Sundry Print Report

Well Name: POKER LAKE UNIT

Well Number: 263H

Type of Action: Plug and Abandonment

PLU 263H - Proposed WBD

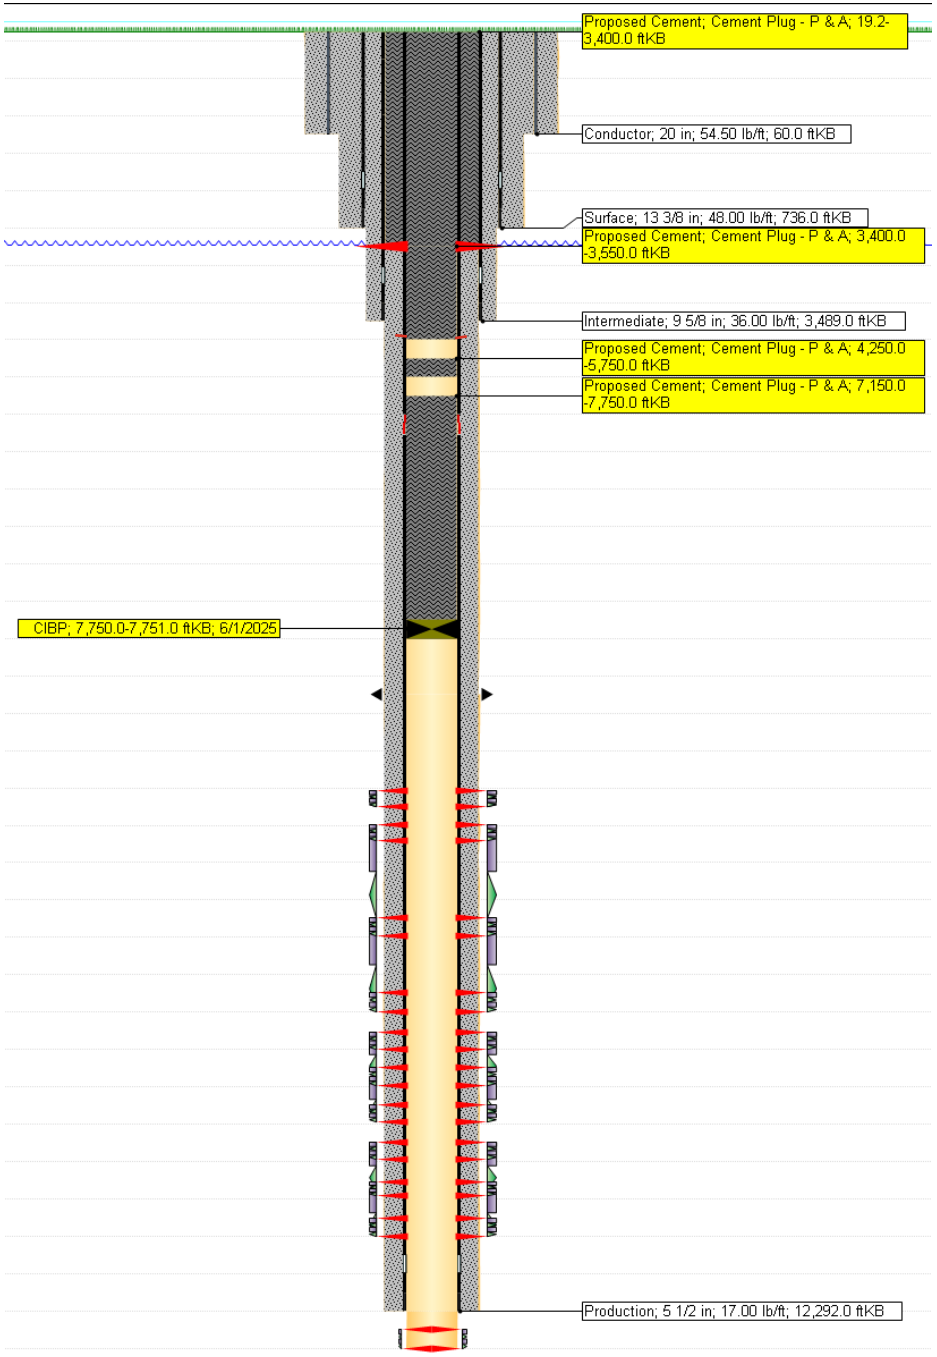
REVISED
4:13 pm, May 14, 2025

REVISED
4:21 pm, May 14, 2025

Perf and circulate from 790' to surface. 240 sacks Class C.

Perf and attempt squeeze from 3539' to 3371'. 52 SKS Class C: WOC and Tag.

Spot 160 SKS Class C: 5,750′ to 4,250′. WOC and

Spot 87 SKS **Class H** atop CIBP: 7,750′ to 7044′. PT CIBP to 500 PSIG for 30 min. WOC and Tag.
